**SAN ANTONIO WATER SYSTEM
CENTRAL WATER INTEGRATION PIPELINE
SEGMENT 5-1
SAWS Job No. 18-8612
SAWS Solicitation No. CO-00181**

**ADDENDUM No. 6
August 9, 2018**

SAN ANTONIO WATER SYSTEM
CENTRAL WATER INTEGRATION PIPELINE
SEGMENT 5-1
**SITE IMPROVEMENT PLAN
AT VOIGT**

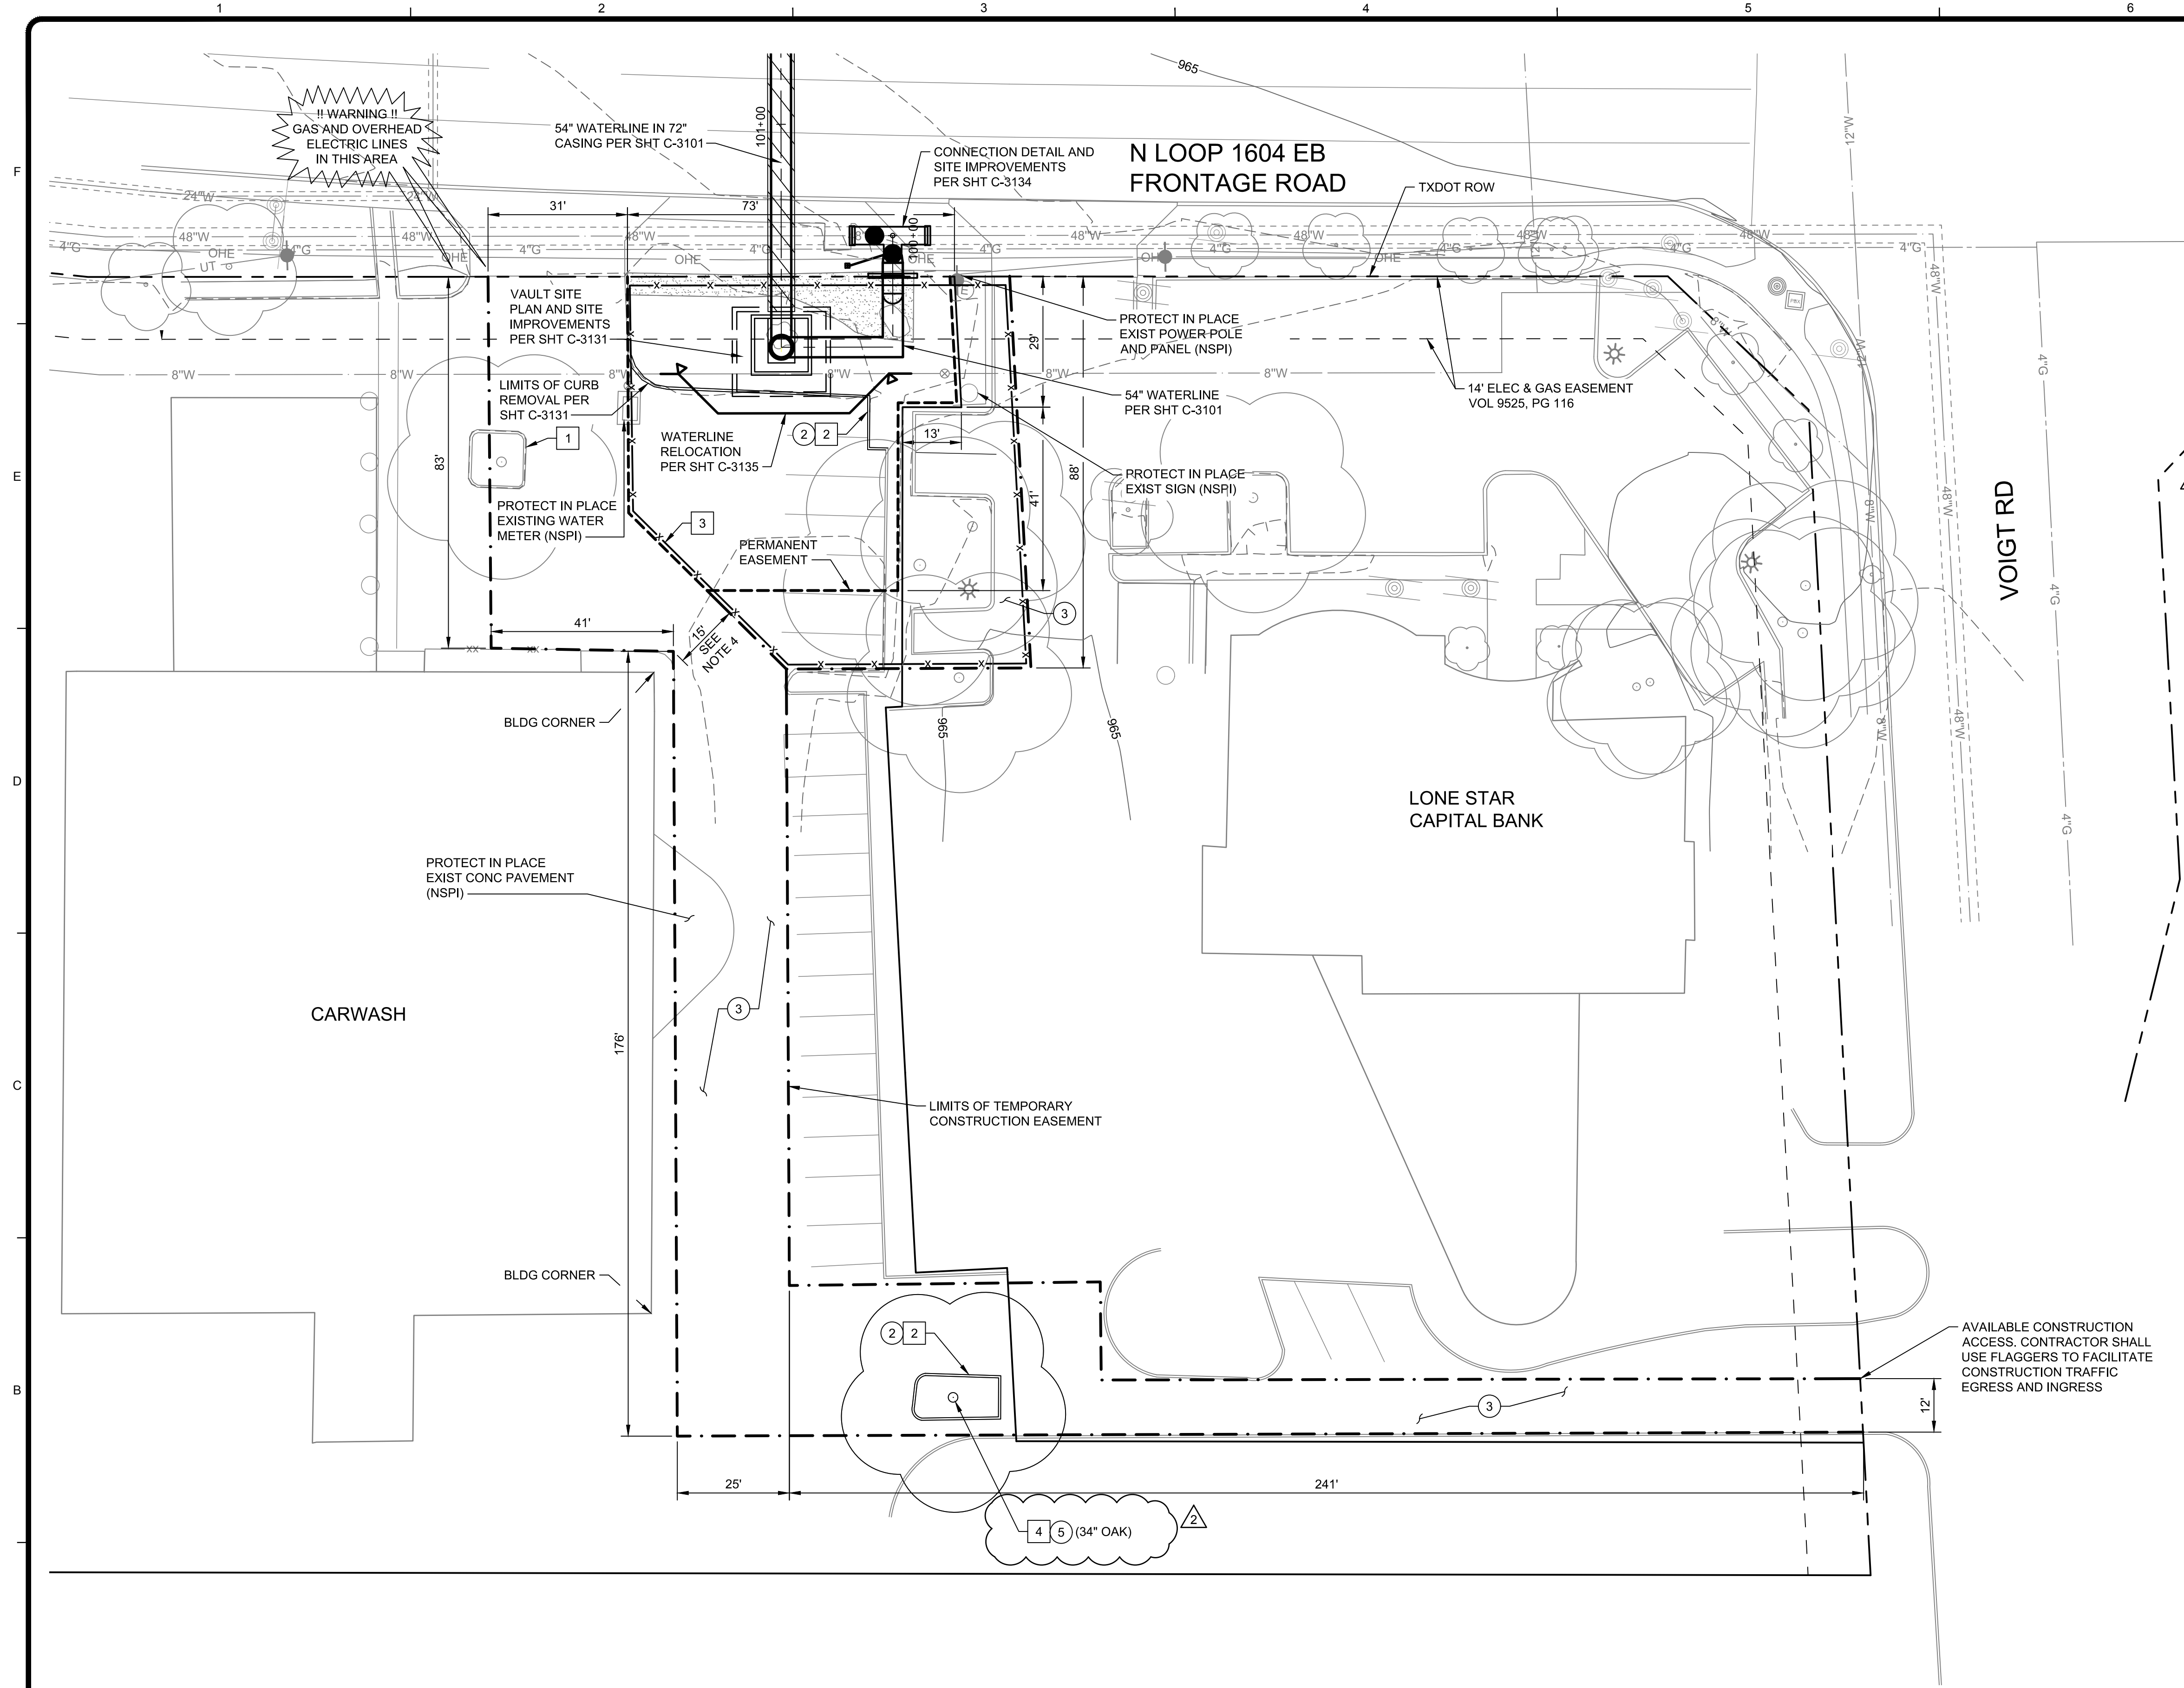
SHEET C-3130 – SITE IMPROVEMENT PLAN AT VOIGT

- a) Delete Sheet C-3130 in its entirety and replace with the revised version included in this Addendum.

SAN ANTONIO WATER SYSTEM
CENTRAL WATER INTEGRATION PIPELINE
SEGMENT 5-1
**SITE IMPROVEMENT PLAN
AT CORNERSTONE**

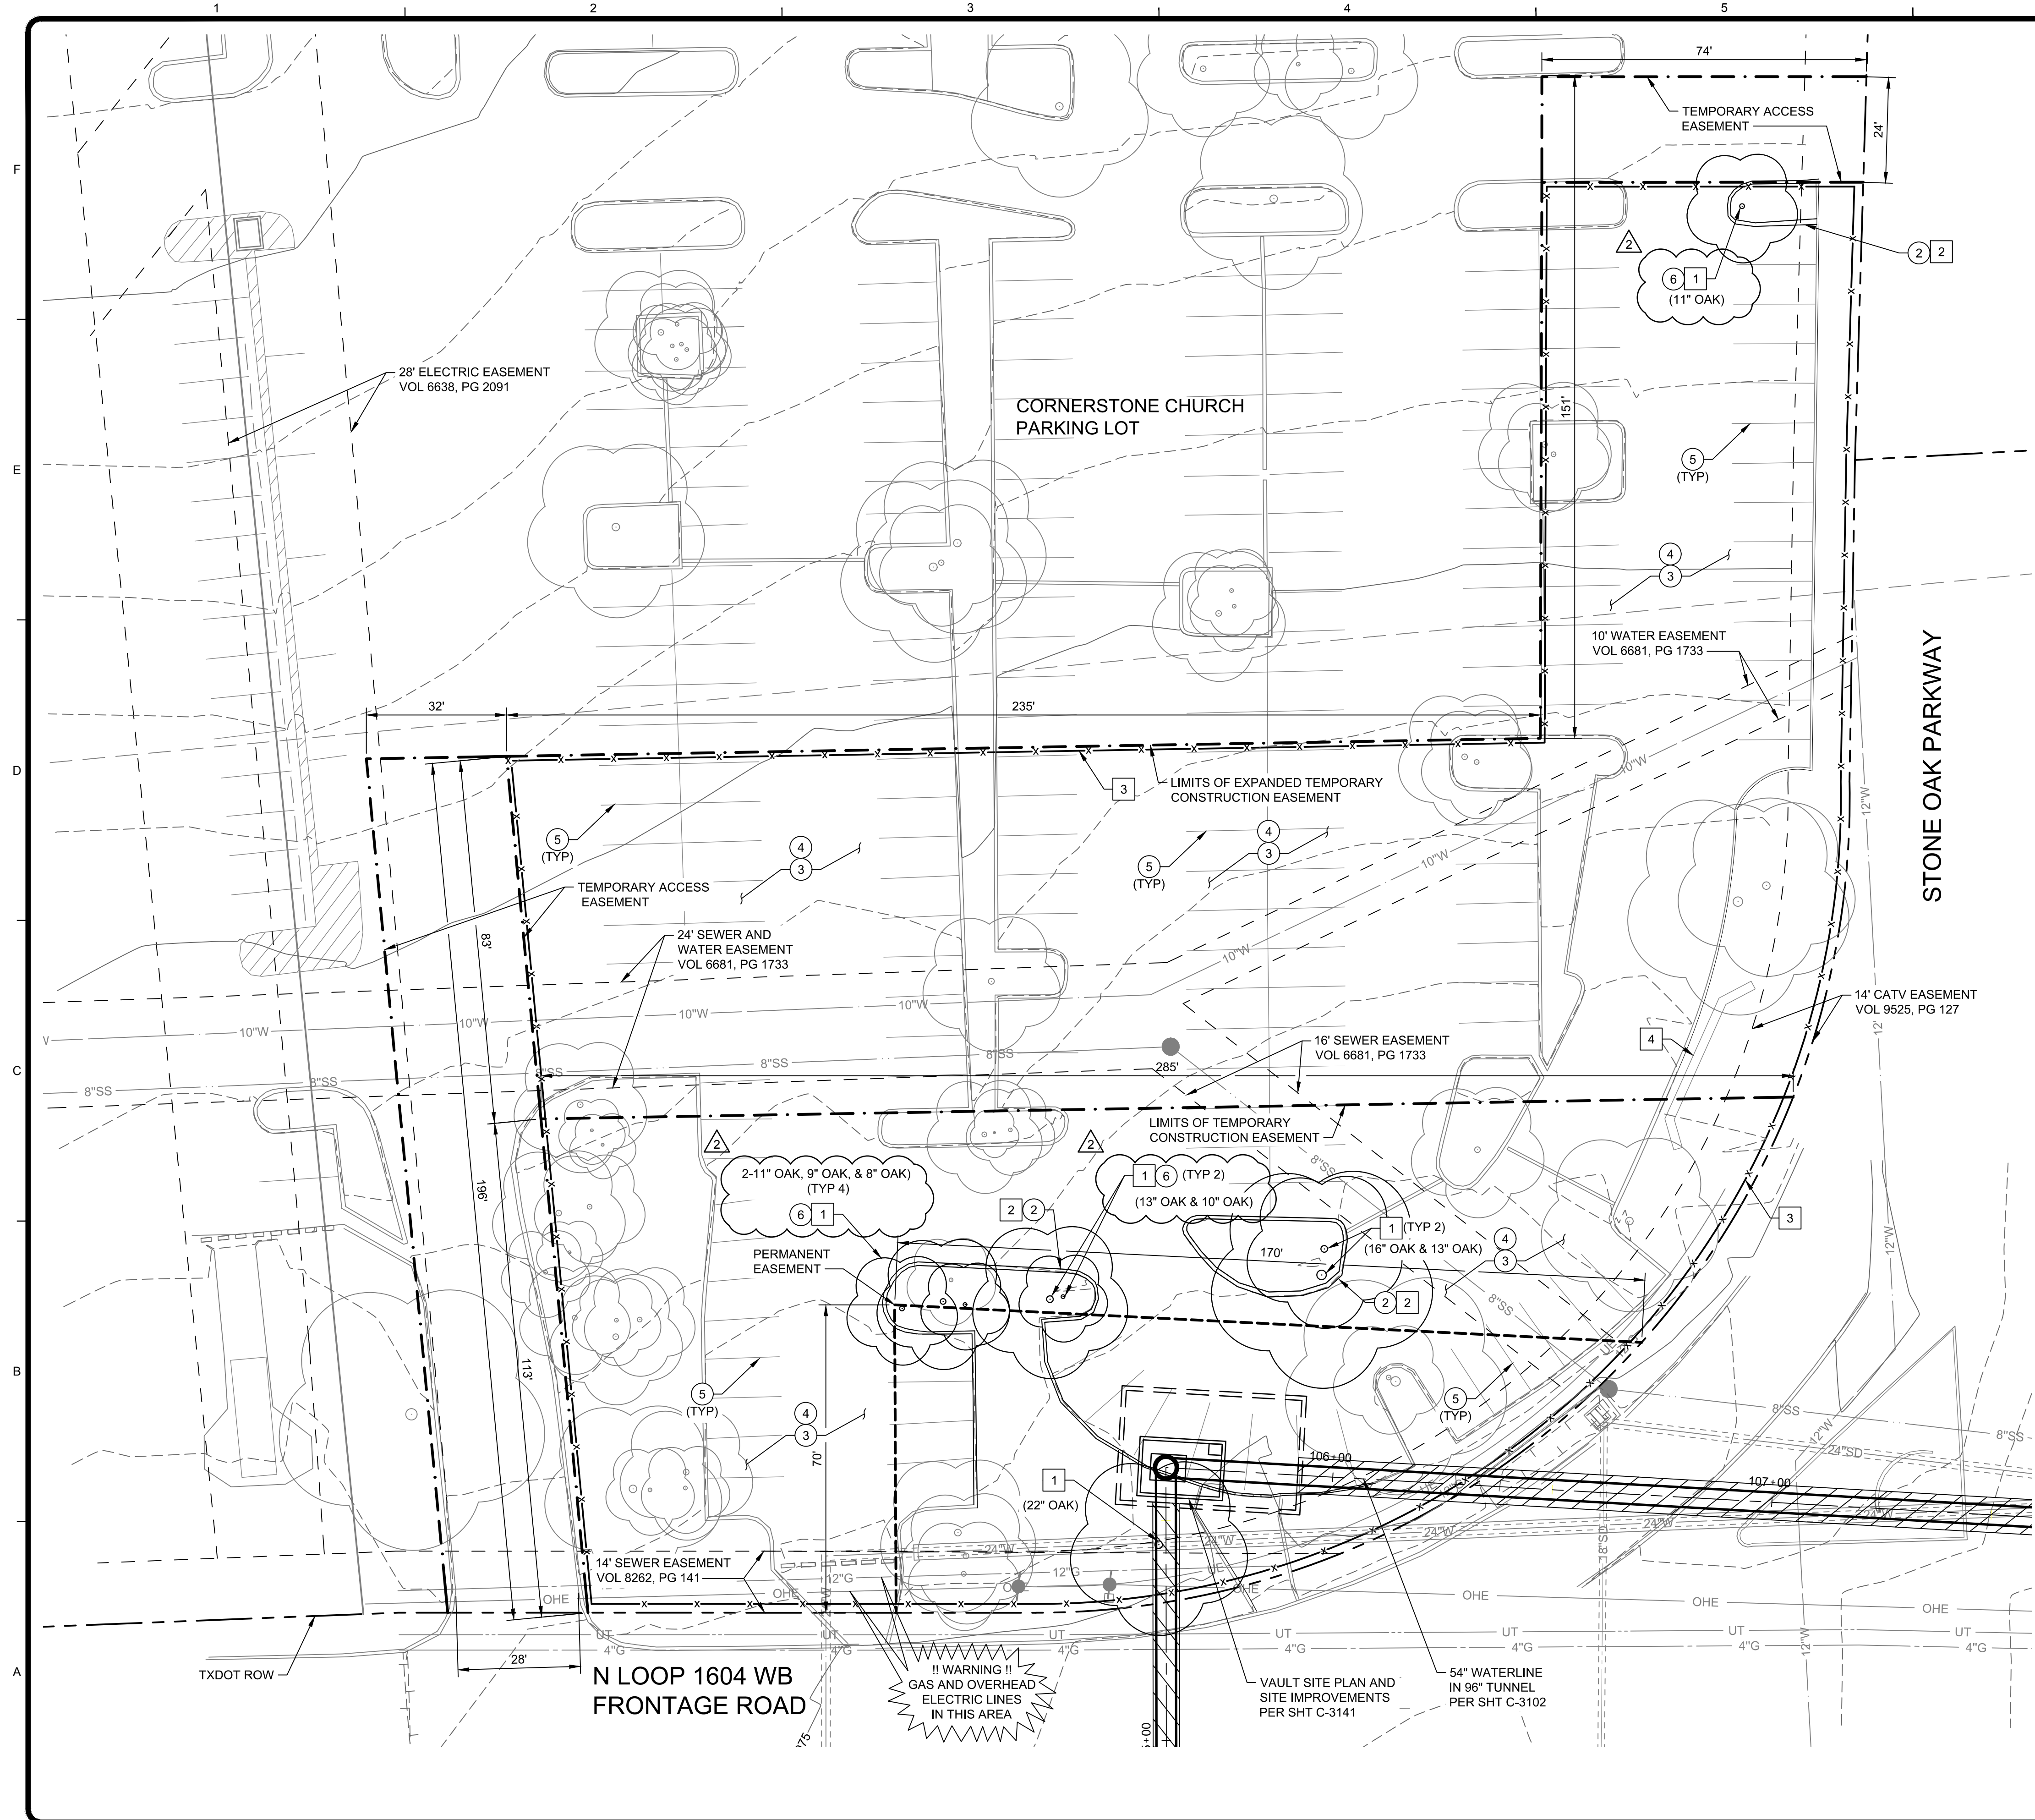
SHEET C-3140 – SITE IMPROVEMENT PLAN AT CORNERSTONE

- a) Delete Sheet C-3140 in its entirety and replace with the revised version included in this Addendum.

L-101

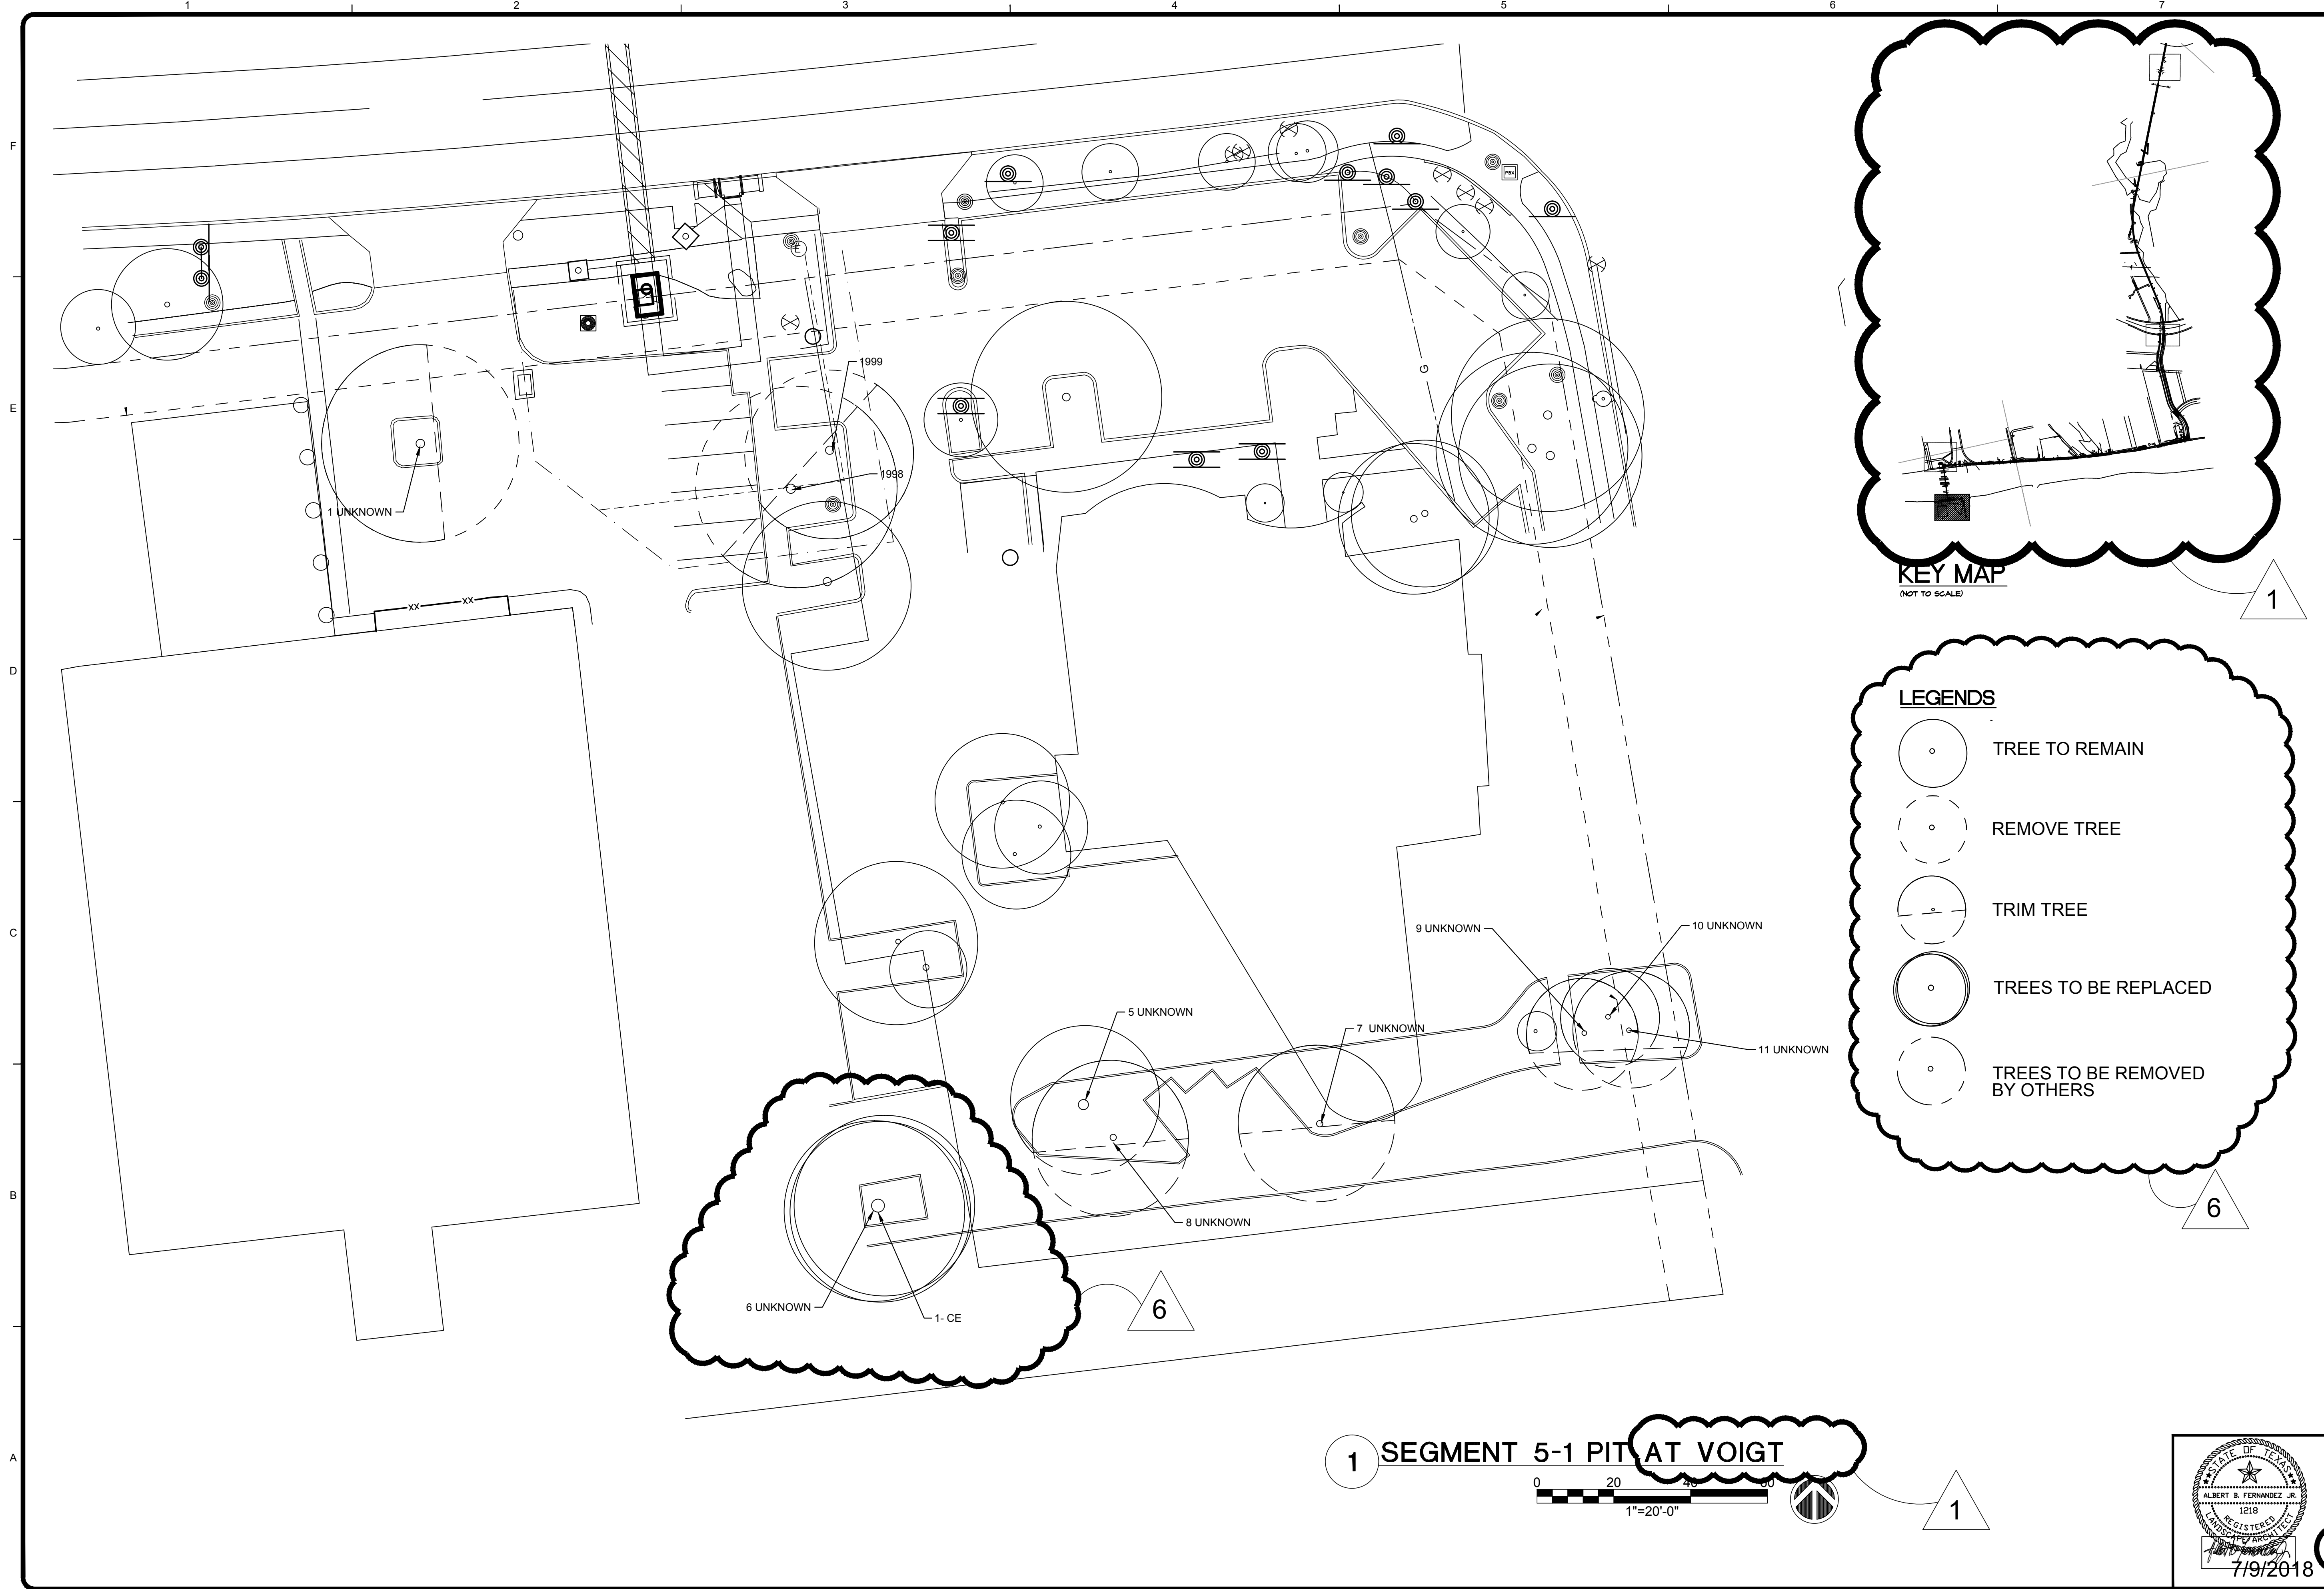
SHEET L-101 – TREE PLAN

- a) Delete Sheet L-101 in its entirety and replace with the revised version included in this Addendum titled “TREE PRESERVATION PLANS”
